**Project Name:** Delray Oasis Business Park

**Request:** Class II Site Plan Application

## SITE PLAN REVIEW AND APPEARANCE BOARD

Meeting: December 11, 2019 | File No.: 2020-043-SPM-SPR-CLII | Application Type: Delray Oasis Business Park

16516  
SP1

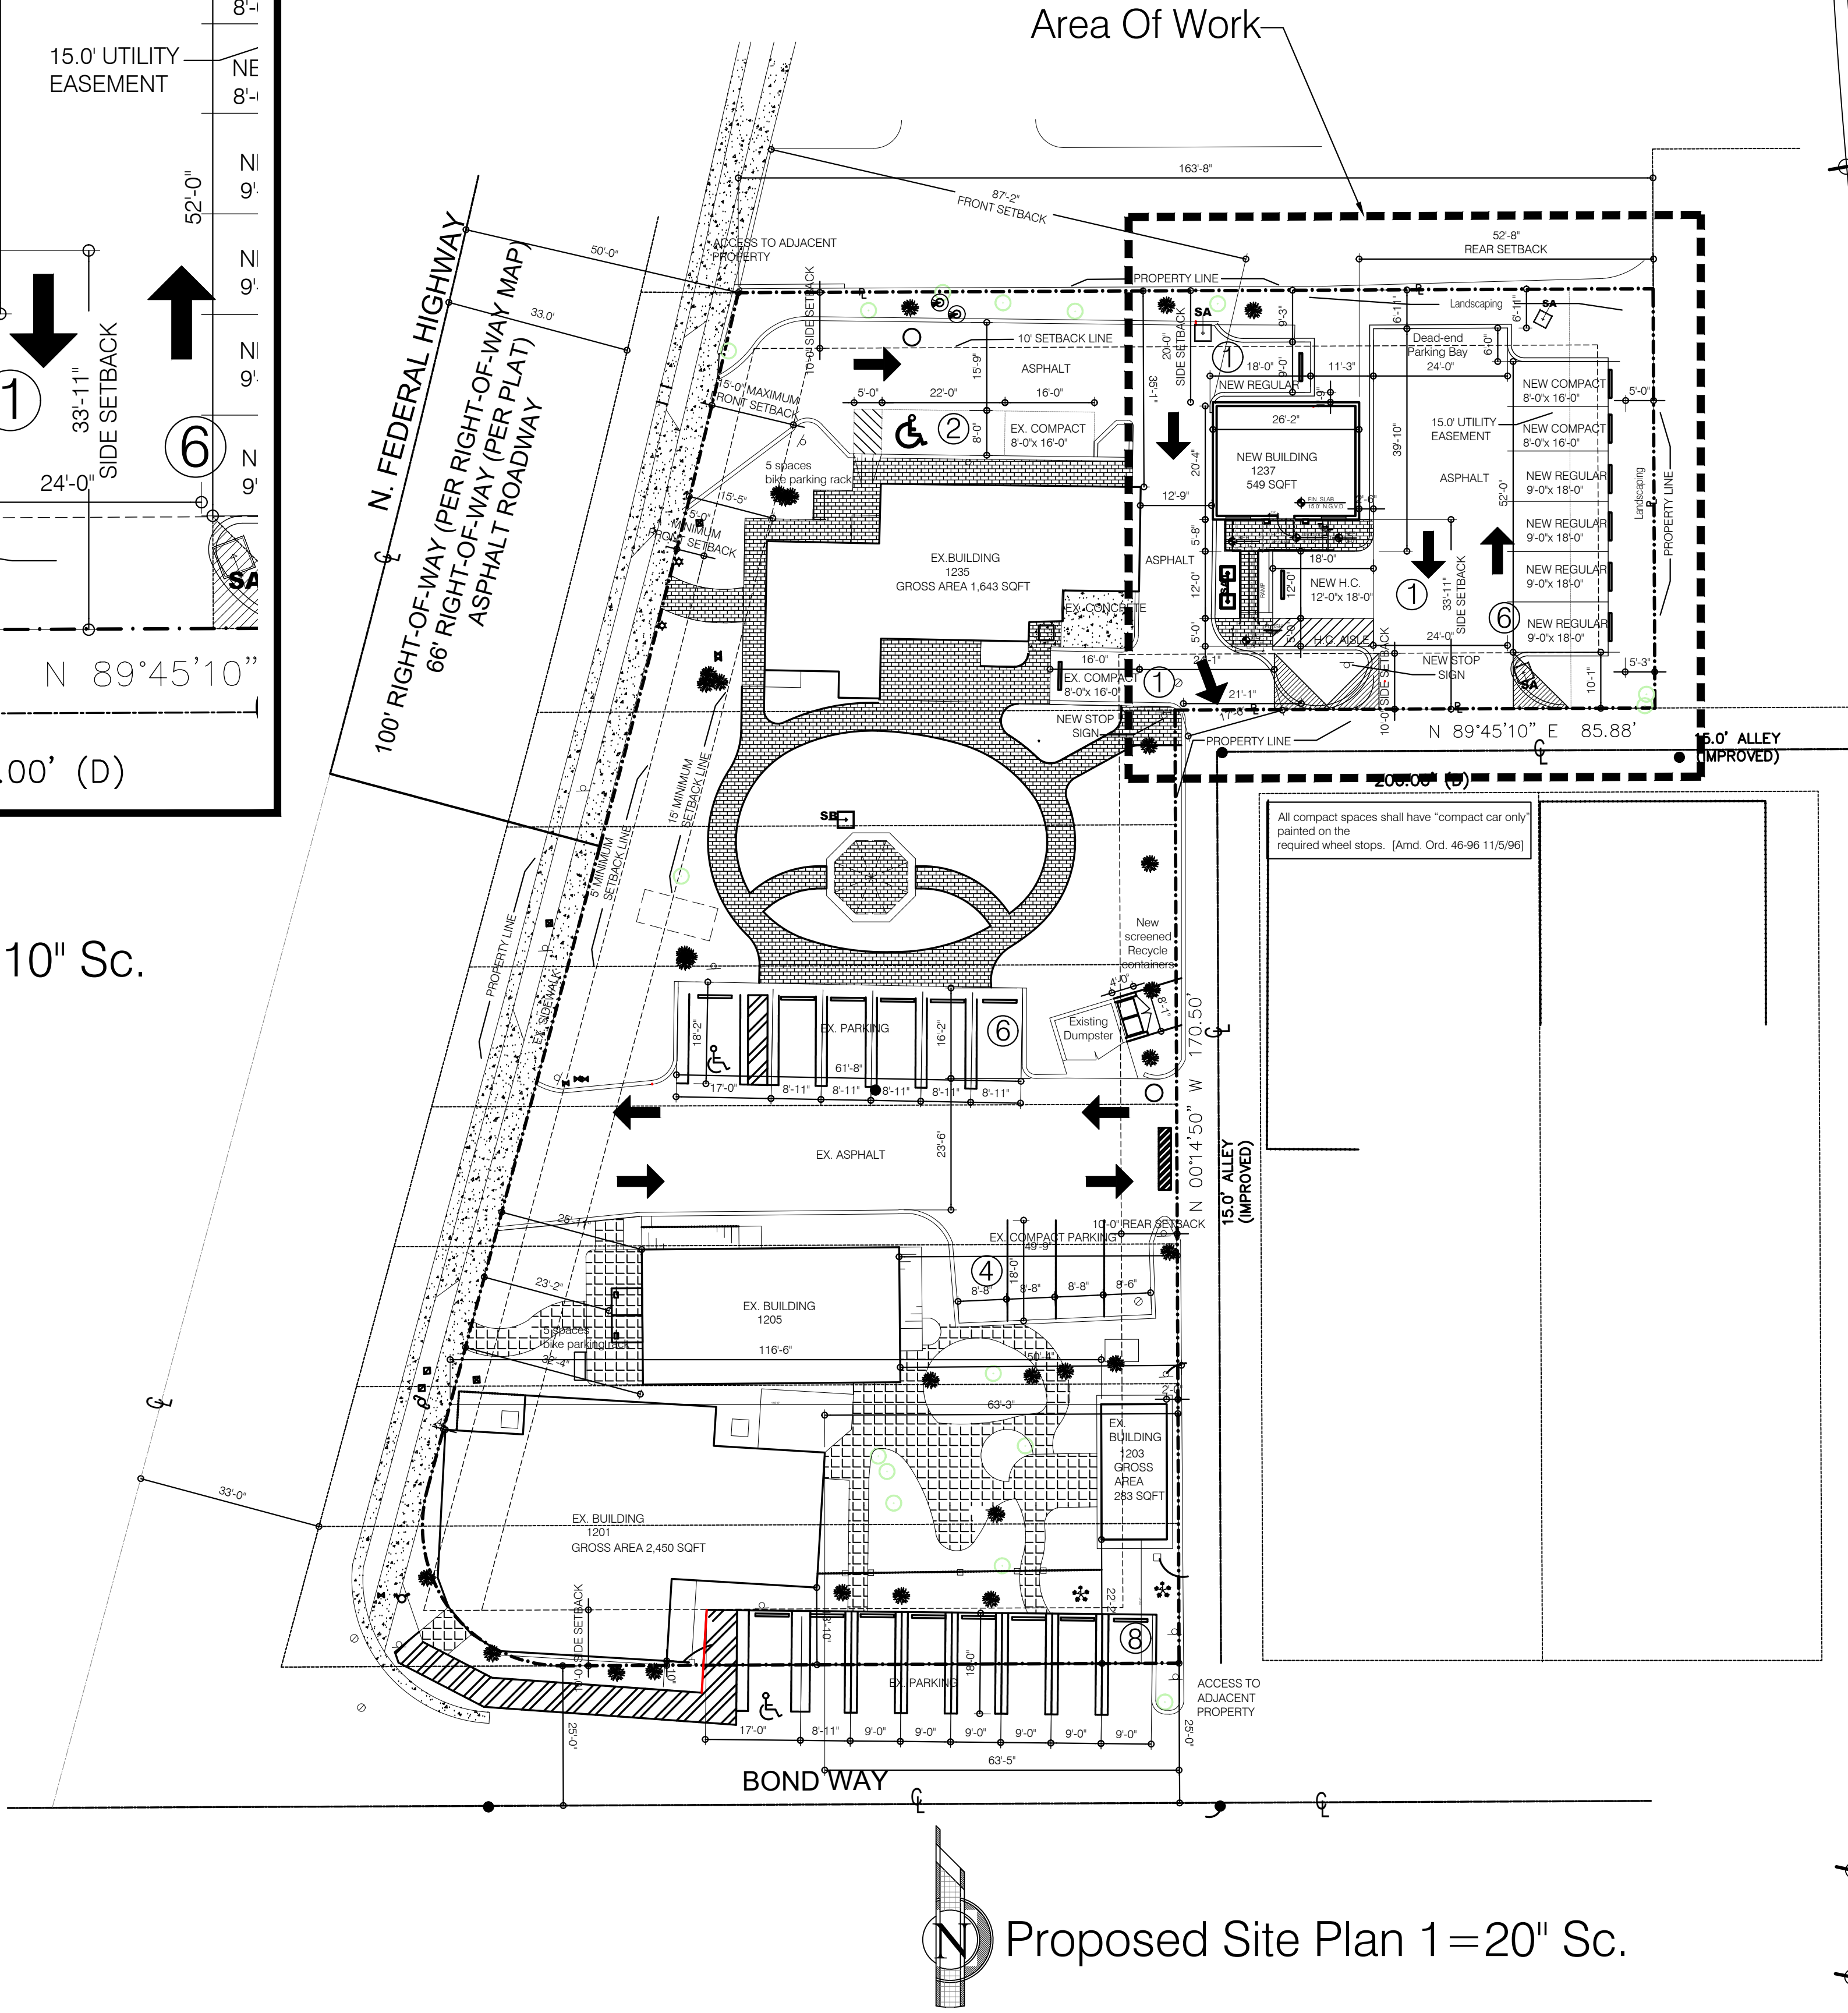
1. Prior to site plan certification update the uses on the parking requirement table on page SP1.
2. Prior to site plan certification label the finish elements provided with the application on the building elevation pages SP4 and SP5.
3. Prior to site plan certification update the photometric plan page to increase the minimum foot candles along the walkway

16516  
SP5

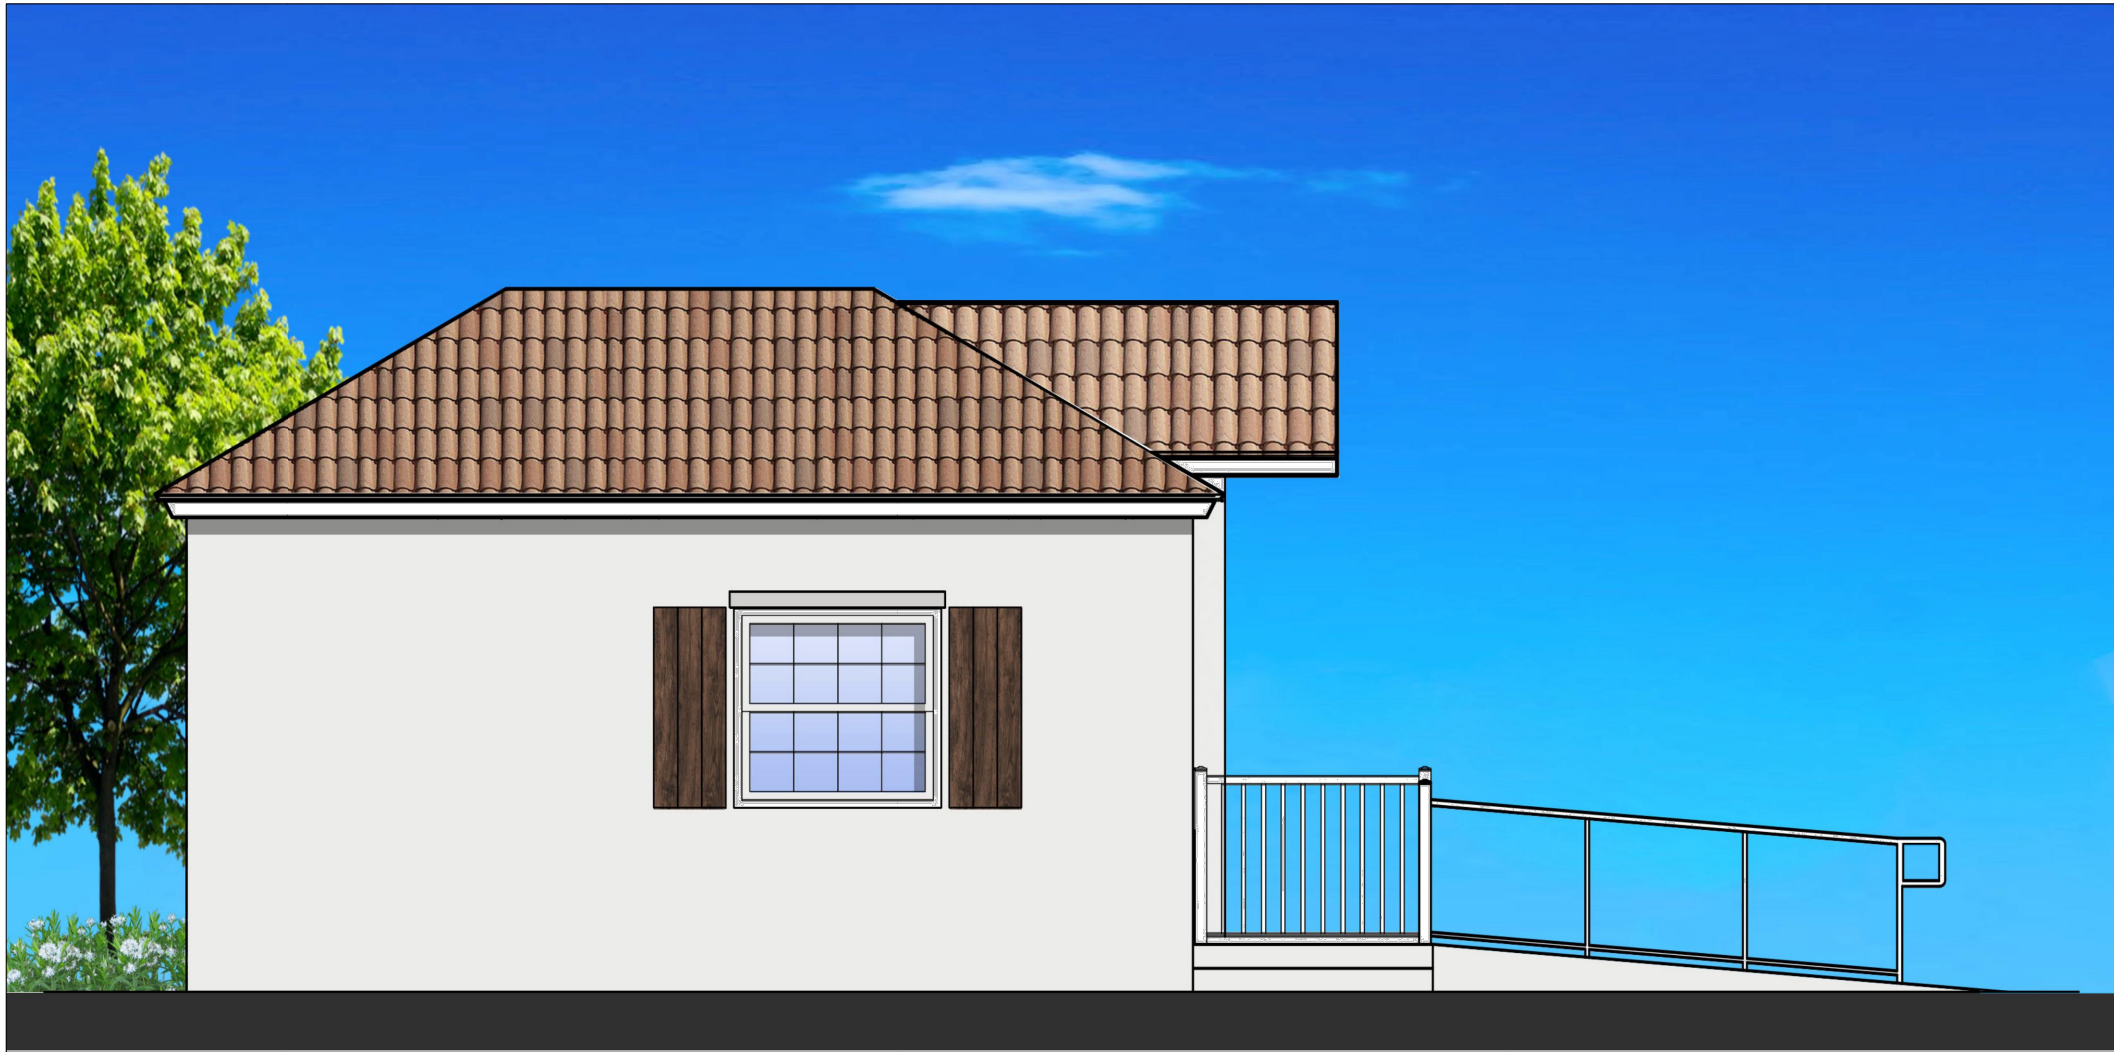
The board approved the project with the stipulation that the 1237 building's roof replicate the same tiles as on the other buildings.
